Supplement to ASME B18.2.6-2010 Fasteners for Use in Structural Applications

The supplement correction listed below applies to ASME B18.2.6-2010. This supplement was approved by the American National Standards Institute (ANSI) on May 5, 2011. See revised table on the overleaf.

Table 1 Dimensions of Heavy Hex Structural Bolts

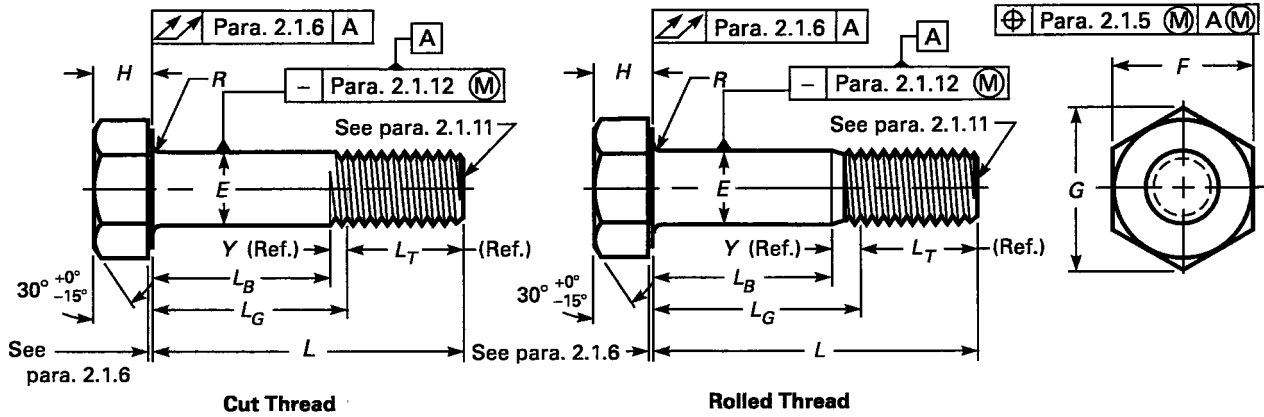
<i>Page</i>	<i>Location</i>	<i>Change</i>
2	Table 1	Note (6) added

- (1) See para. 2.4.1.
- (2) See paras. 2.1.2 and 2.1.3.
- (3) See para. 2.1.4.
- (4) See para. 2.1.10.2.
- (5) See para. 2.1.6.
- (6) The body diameter limits are shown in this table. Any swell or fin under the head or any die seam on the body shall not exceed the basic bolt diameter by the following:
 - (a) 0.030 in. for sizes 1/2 in.
 - (b) 0.050 in. for sizes 5/8 in. and 3/4 in.
 - (c) 0.060 in. for sizes over 3/4 in. through 1 1/4 in.
 - (d) 0.090 in. for sizes over 1 1/4 in.
